METROPOLITAN GOVERNMENT OF NASHVILLE AND DAVIDSON COUNTY

STAFF RECOMMENDATION
925 Russell Street
May 20, 2015

Application: New construction—infill and outbuilding; Setback determination
District: Edgefield Historic Preservation Zoning Overlay
Council District: 06
Map and Parcel Number: 08216011400
Applicant: Van Pond, Jr., architect
Project Lead: Melissa Baldock, melissa.baldock@nashville.gov

Proposed Site Plan Layout

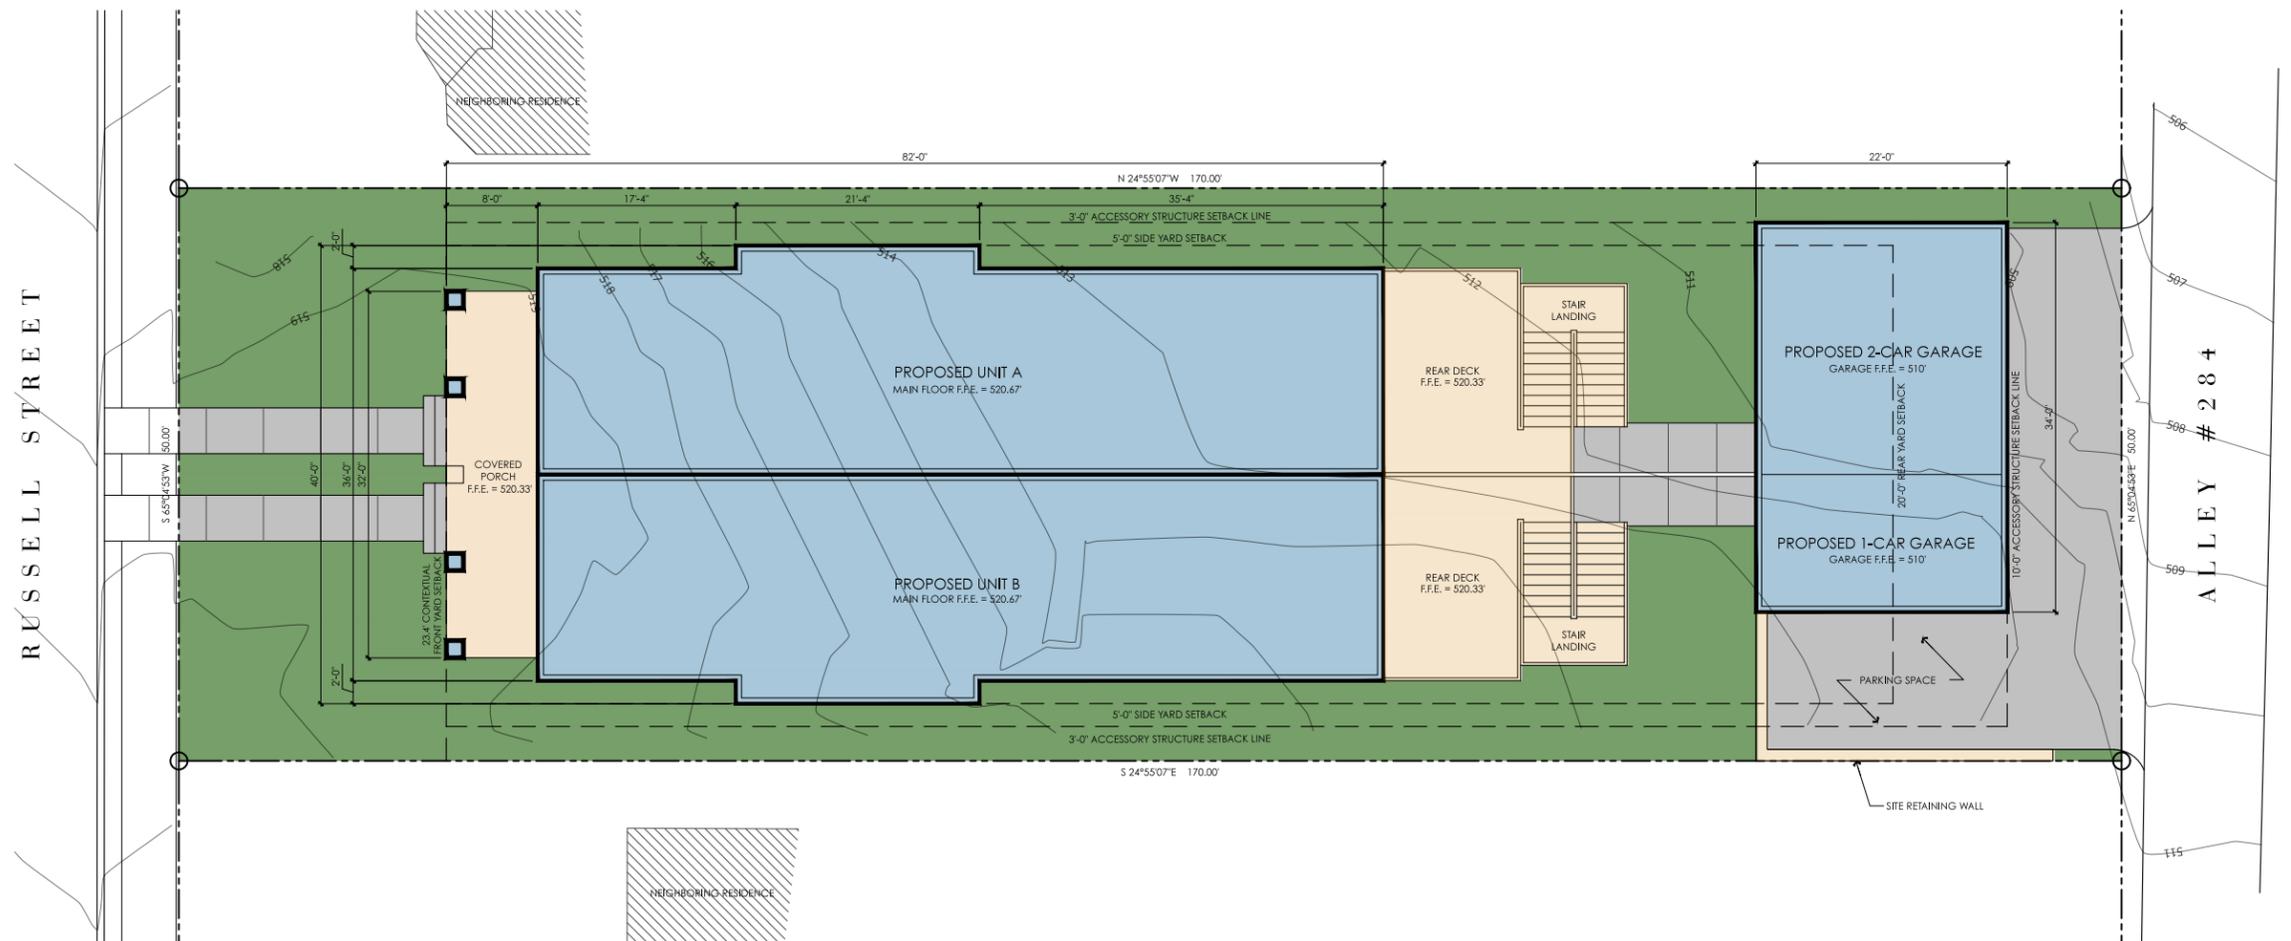
Setback and Rhythm of Spacing. The proposed infill meets all base zoning setbacks. It is centered on the lot and is a minimum of five feet (5') from the side property lines. Its front setback is the approximate average of the front setbacks of the two neighboring properties, which is appropriate. Staff finds that the infill's setback and rhythm of spacing meet Section III.B.2.a. of the design guidelines.

Appurtenances & Utilities: In an historic preservation overlay like Edgefield, the Metro Historic Zoning Commission reviews and regulates all permanent site features, including, but not limited to, HVAC and utility placement, fencing, retaining walls, walkways, and vehicular paving areas. The site plan indicates that a retaining wall is planned for the rear of the site, near the uncovered parking space on the east side of the property. Staff asks to review the design, height, and material of this retaining wall. Staff also asks to review

the placement of the HVAC and other utilities, as well as any fencing and other permanent site features not indicated on the submitted plans.

1. The finished floor height be consistent with the finished floor heights of the adjacent historic houses, to be verified by MHZC staff in the field;
2. Staff approve the final details, dimensions and materials of windows and doors prior to purchase and installation;
3. Staff approve the materials of the porch floor and steps, walkways, and rear paving materials;
4. Staff review and approve the design and materials of the rear retaining wall and all other site features; and
5. The HVAC shall be located behind the house or on either side, beyond the mid-point of the house.

Proposed Roof Plan

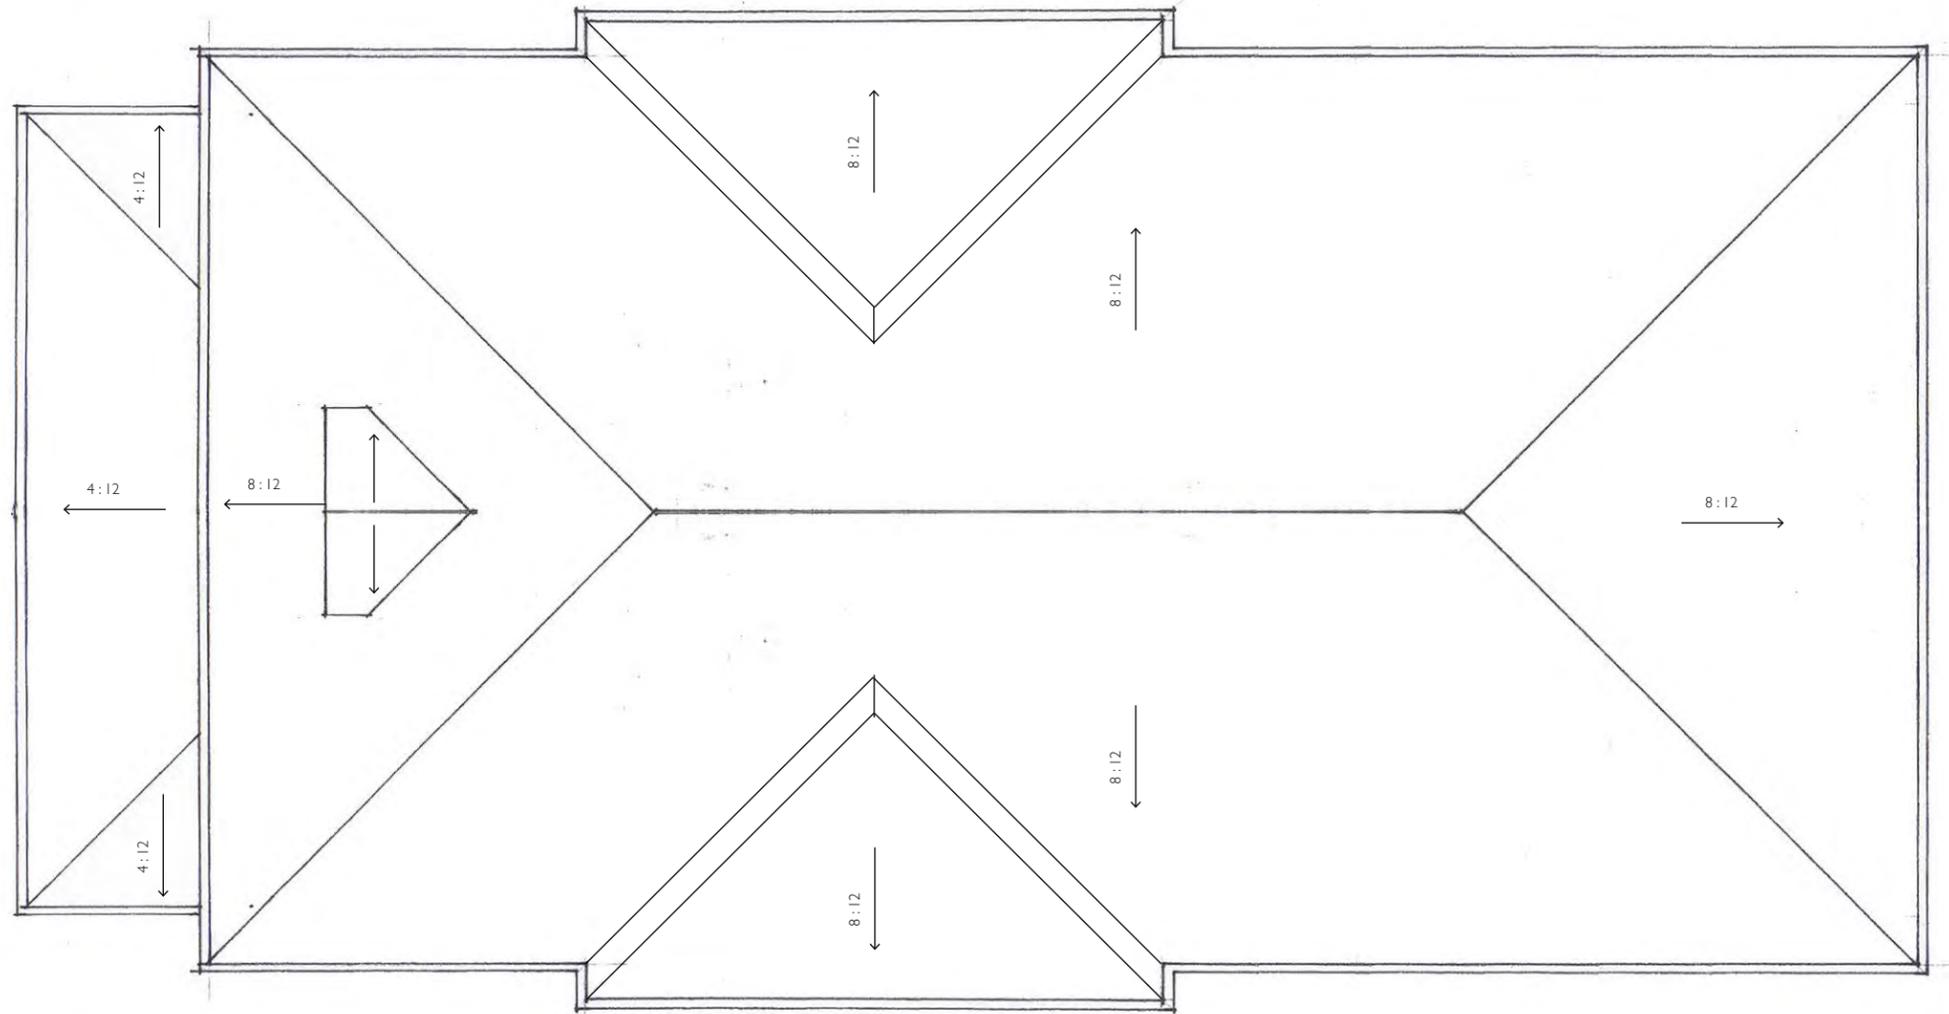
Roof. The infill's primary roof form will be a hipped roof with an 8/12 pitch. This roof form will help reduce the visible impact of the infill's height. The two-story bays will also have 8/12 hipped roof forms. The front dormer will have a gabled roof with a pitch that matches that of the primary roof; the dormer will be appropriate inset at least two feet (2') from the wall below and will be placed at least two feet (2') off of the ridge. The porch roof will be hipped with a 4/12 pitch. Staff finds that the infill's roof forms meet Section III.B.2.d. of the design guidelines.

Proposed Front (South) Elevation

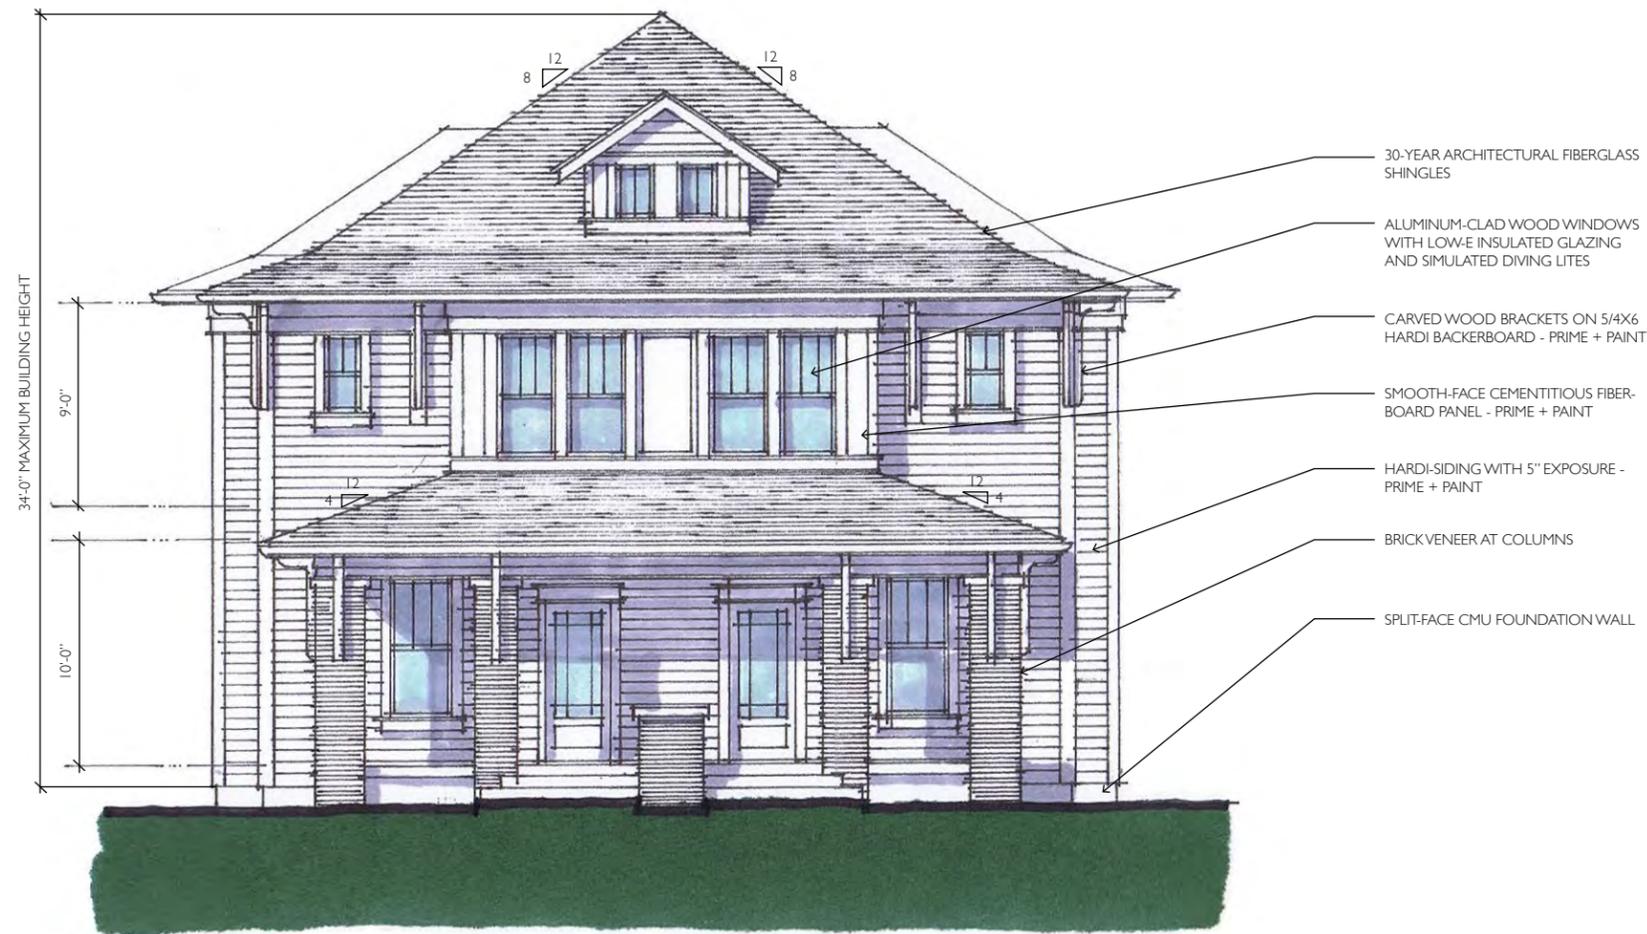
Orientation. The duplex is oriented to face Russell Street, and is symmetrical in design. The duplex will have two identical entries, both facing Russell Street. The two units will share an eight foot (8') deep front porch, but will be accessed via two separate porch stairs and two separate pathways leading from the sidewalk to the front porch. Vehicular access to the site will be from the rear alley. Staff finds that the duplex's orientation meets Section III.B.2.e. of the design guidelines.

Proportion and Rhythm of Openings: The windows on the proposed infill are generally twice as tall as they are wide, thereby meeting the historic proportions of openings. There are no large expanses of wall space without a window or door opening. Staff finds that the infill's proportion and rhythm of openings meet Section III.B.2.f. of the design guidelines.

Proposed Garage Plan

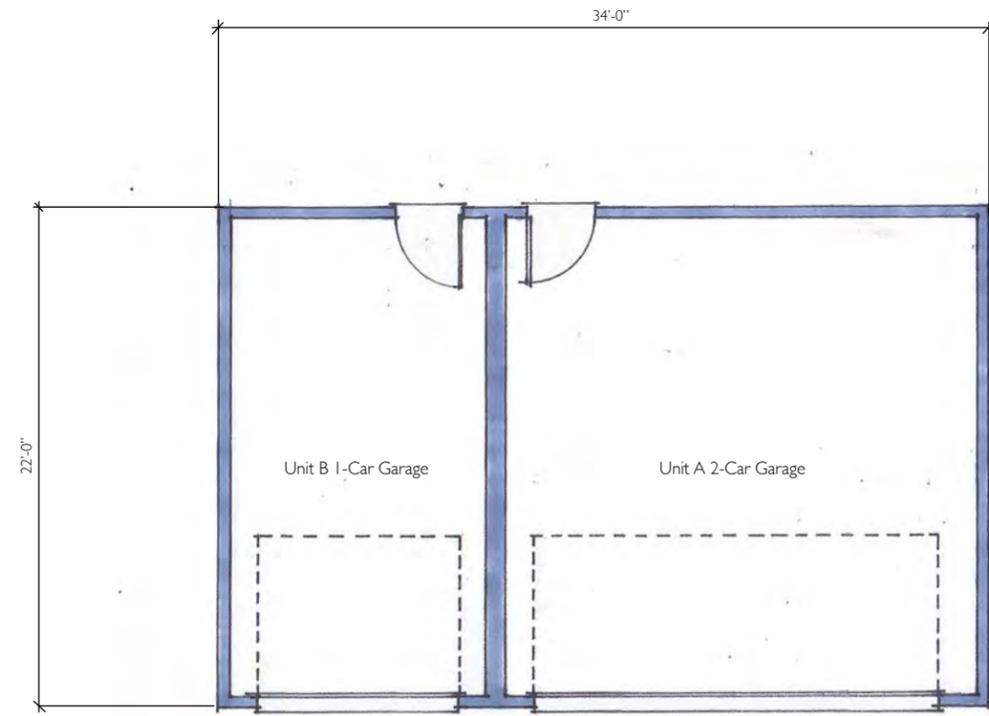
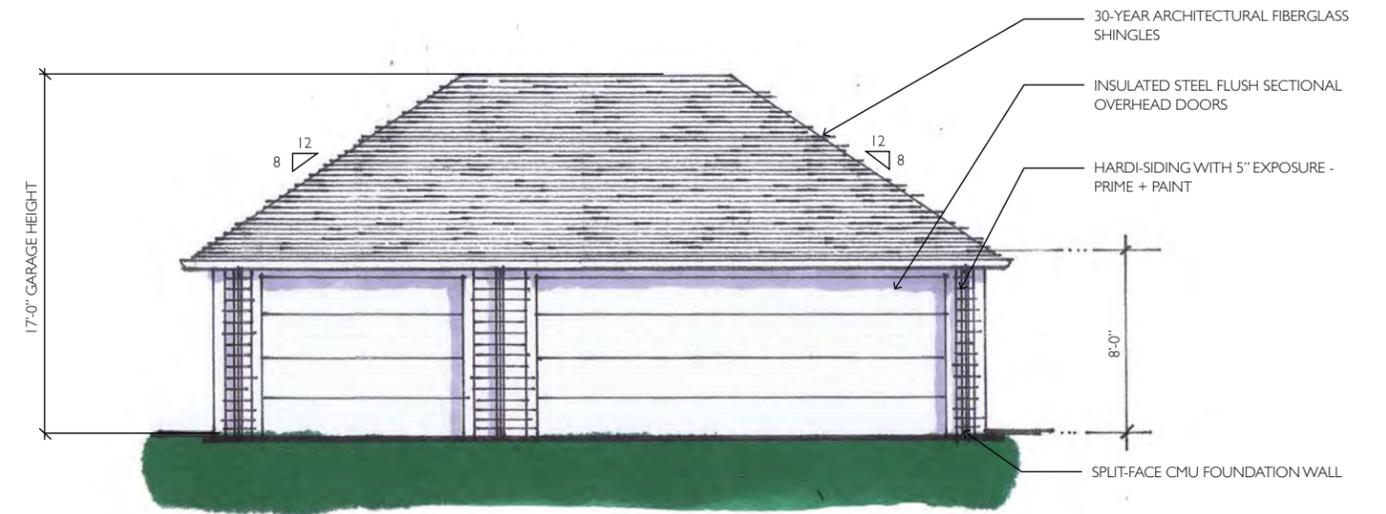
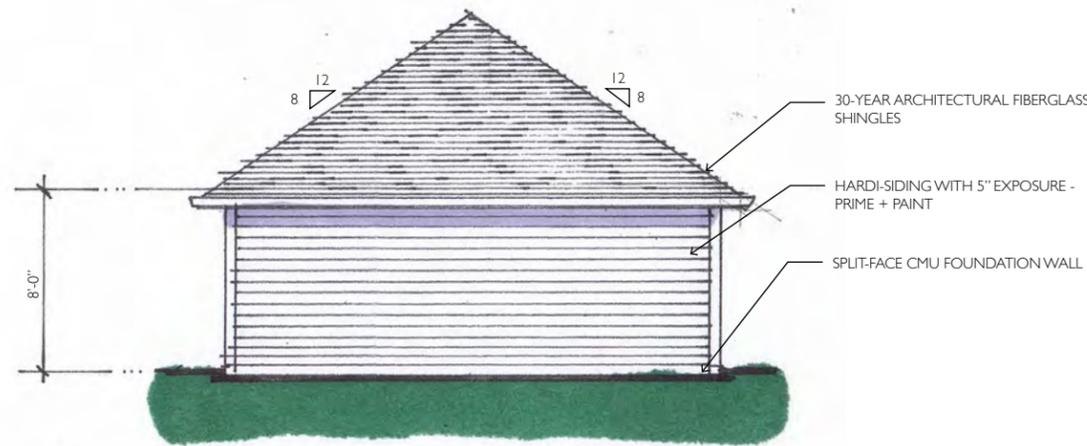
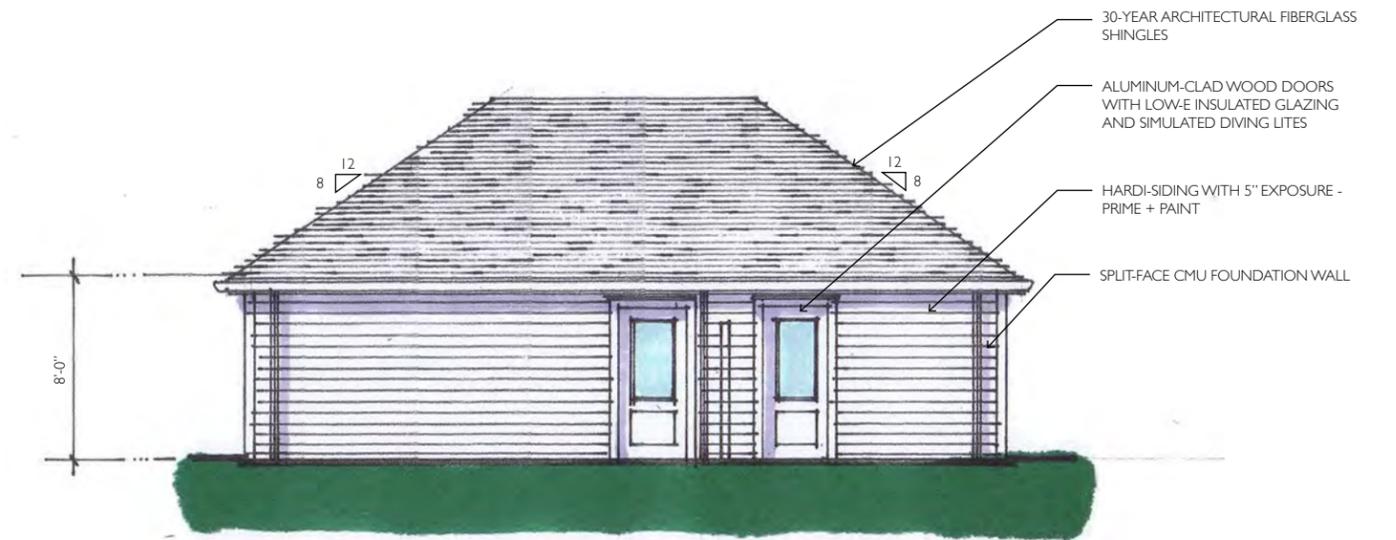
Outbuildings. The applicant is proposing a one-story, three-bay outbuilding. The outbuilding will not contain a detached accessory dwelling unit. See the attached “DADU and Outbuilding Worksheet” for the specifics as to how the outbuilding meets the design guidelines.

The outbuilding will have a footprint of seven hundred and forty-eight square feet (748 sq.ft.). Base zoning requires that outbuildings with footprints greater than seven hundred square feet (700 sq. ft.) be place a minimum of twenty feet (20’) from the rear property line and five feet (5’) from the side property lines. The proposed outbuilding requires setback determinations for the rear and the west side property lines. The applicant is proposing to place the outbuilding ten feet (10’) from the rear property line and three feet (3’) from the west side property line. Staff finds that the proposed setbacks are appropriate because historically, outbuildings like this one were situated close to, and often on, the rear and side property lines. The Edgefield neighborhood has many new and historic outbuildings that have similar setbacks to what is proposed.

The materials for the proposed outbuilding will be similar to those of the infill. The materials include smooth face cement fiberboard siding with a five inch (5”) reveal, architectural fiberglass shingles, steel vehicular doors, and concrete block foundation. Staff asks to review and approve the shingle color and final door selection prior to purchase and installation of these materials. Staff finds that the proposed outbuilding meets Section III.B.2.h. of the design guidelines.
